**ADDENDUM NO. 5  
FOR  
JRF ARFF STATION RENOVATIONS  
KALAELOA AIRPORT  
KAPOLEI, OAHU, HAWAII  
STATE PROJECT NO. CO4420-33**

**October 18, 2024**

**RESPONSES TO REQUESTS FOR INFORMATION (RFI'S/QUESTIONS)**

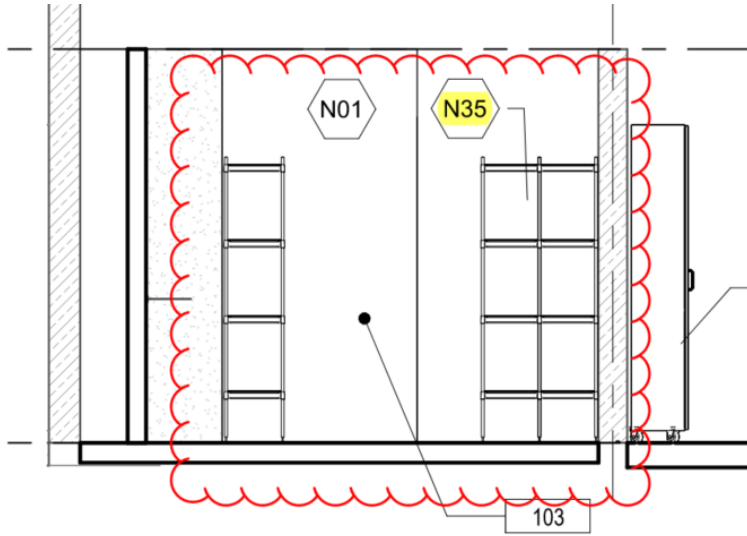
2. **QUESTION:** Sheet PD101 has callout to “Remove (E) gas range, modify (E) gas line for new range connection. If there is a new oven-range to be provided, please provide specifications.

**RESPONSE:** Commercial Grade 60” Gas Range – 6 open burners/ 24” griddle. Refer to equipment schedule.

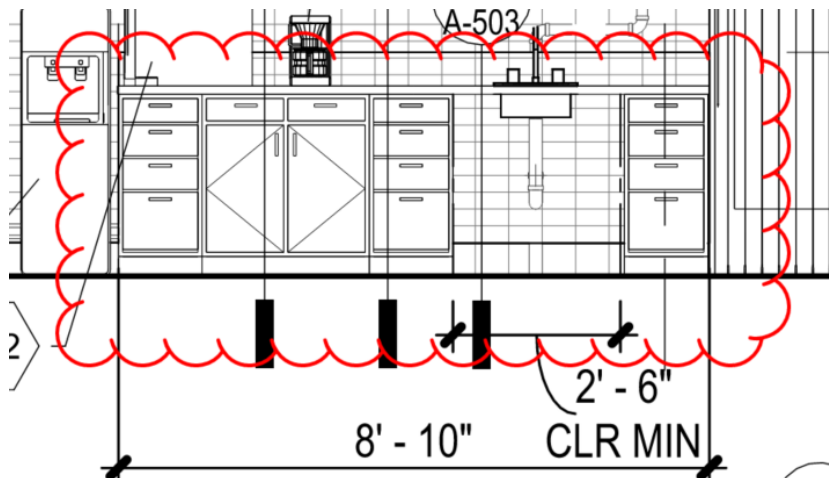
5. **QUESTION:** Reference Equipment Schedule Sheet A-603, Item E12 – Undercounter Dishwasher (ADA Compliant).  
Please specify make and model number for this item.

**RESPONSE:** Commercial Grade 32” x 23.5” x 22.38” ADA compliant undercounter dishwasher.

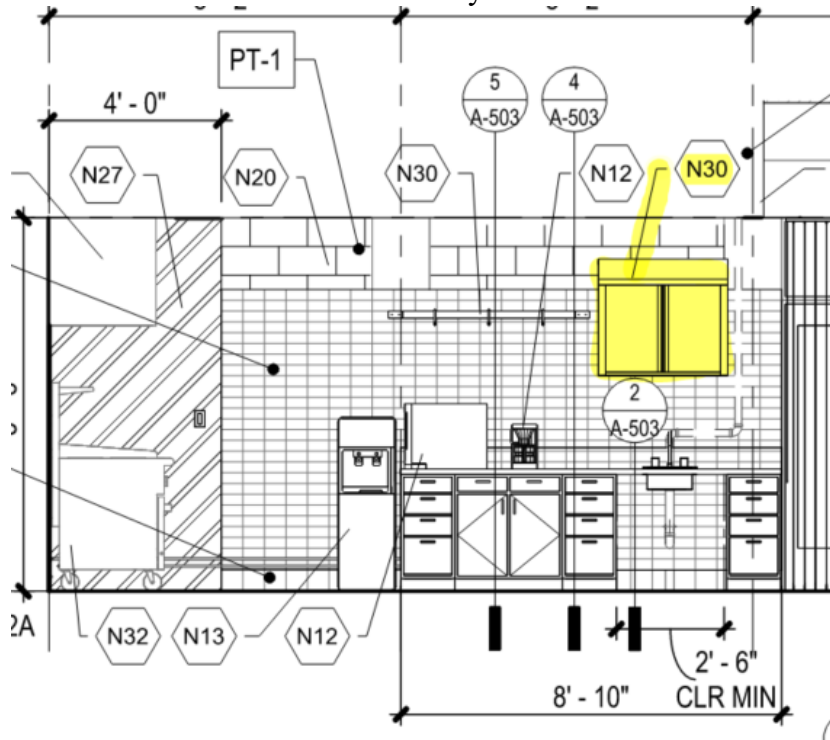
6. **QUESTION:** Reference Equipment Schedule Sheet A-603, Item E25 & E26 – Stainless Steel Base Cabinets, Sheet A-404, Elevation 2A  
Are there more fabrication details for these items?

**RESPONSE:** Commercial Grade pmanufactured freestanding SST base cabinets. Refer to casework details.

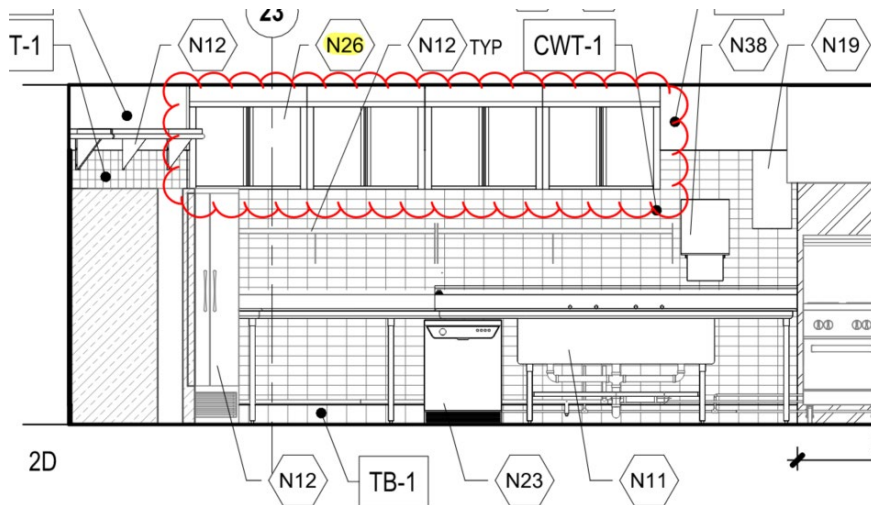
7. **QUESTION:** Reference Sheet A-404, Elevation 2A, Keynote N30 – Wall Mounted S/S Pot Rack  
 There is an additional Keynote N30. One shows the pot rack and the other shows a wall mounted cabinet. Please clarify.

**RESPONSE:** Follow equipment schedule – Sheet A-604 for clarification between wall mounted cabinet and pot rack. Highlighted element is wall mounted cabinet.

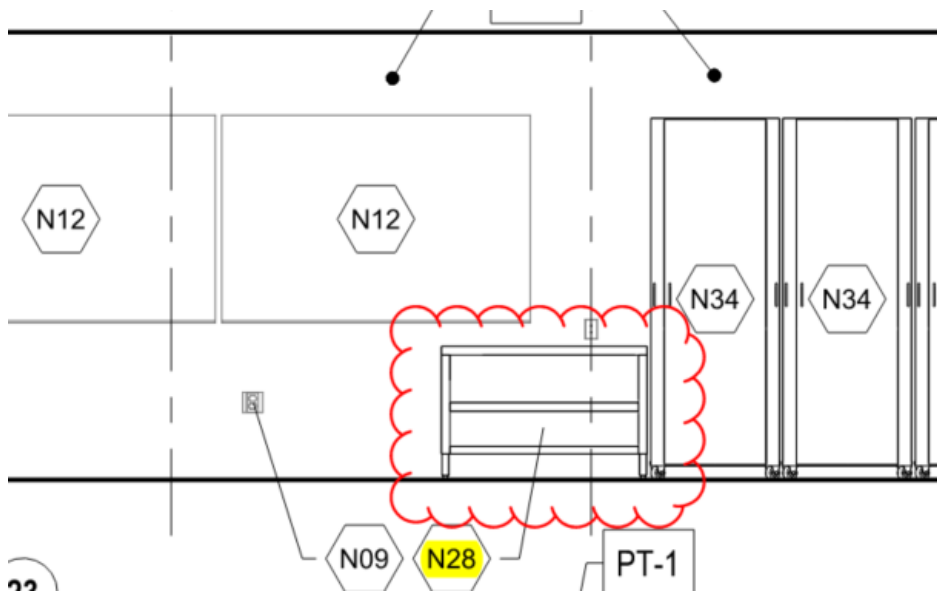
8. **QUESTION:** Reference Sheet A-404, Elevation 2D, Keynote N26 – S/S Cabinet  
 a. This is not listed as part of the Equipment List on Sheet A-603. Should this be included in pricing?

b. If this is to be included in pricing, are there more fabrication details for this item?

**RESPONSE:** Wall-mounted cabinets should be included in pricing. Refer to equipment schedule.

Commercial Grade premanufactured Wall Mounted SST cabinets. Refer to the equipment schedule.
